RECEIVED
 DEC 05 2006
 RESUBMIT APPROVED AS NOTED
 BY Opw DATE 12/12/06

This drawing is based upon information provided from the following documents and/or sources:
 Engineer: VAOT
 Project No: ST CULV (4)
 Drawings: PROPOSED IMPROVEMENT BRIDGE PROJECT - VT RTE 8, RURAL MAJOR COLLECTOR
 Sheets 1 through 39 of 39 sheets
 Readsboro AC STP ST CULV (4) - Special Provisions
 Supplemental Specifications - Schedule of Prices
 Other Sources:

PIKE INDUSTRIES
 VT RTE 8, RURAL MAJOR COLLECTOR
 READSBORO, VT
 BOX CULVERT WINGWALL DETAILS - BRIDGE NO. 02
 C18331-L01-3
 Drawing No. 1
 Quantity: 1 Project No: AC STP ST CULV (4) SHEET 3 OF 3

ELEVATION D-D
1 of 2

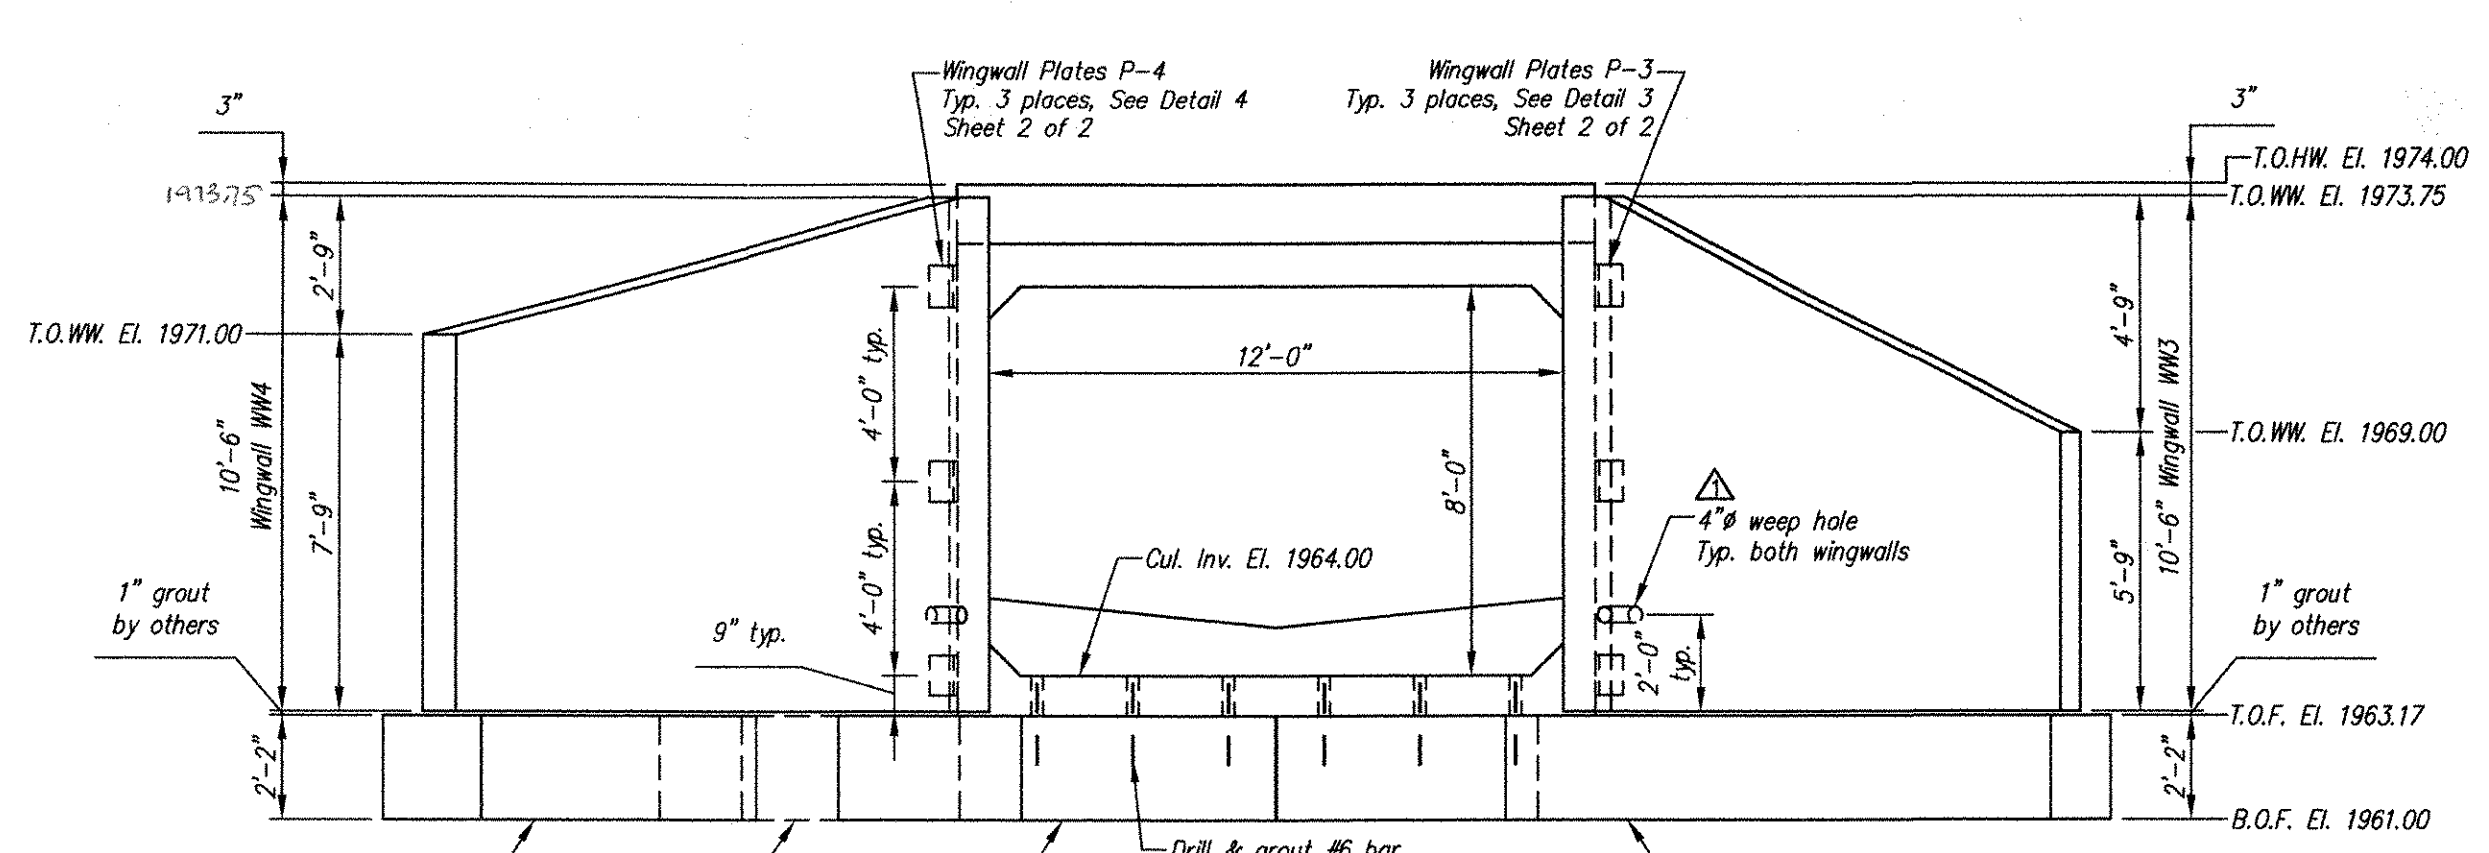
Rev.	Date	DESCRIPTION	By
5			
4			
3			
2			
1	11/21/06	Called out 4" weep holes in Elevation D-D & E-E; WW1 revised to be 20' in piece schedule	MS

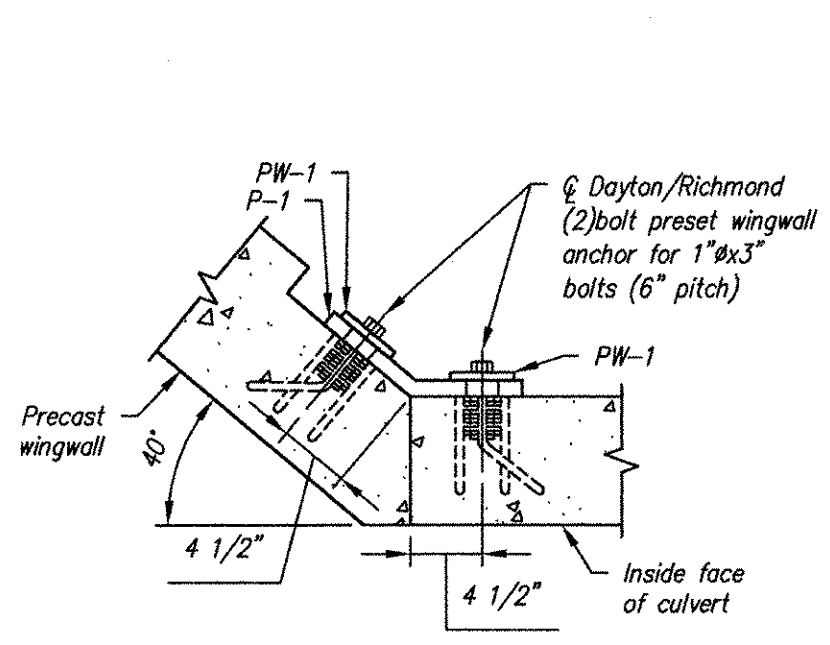
ADD TABLE
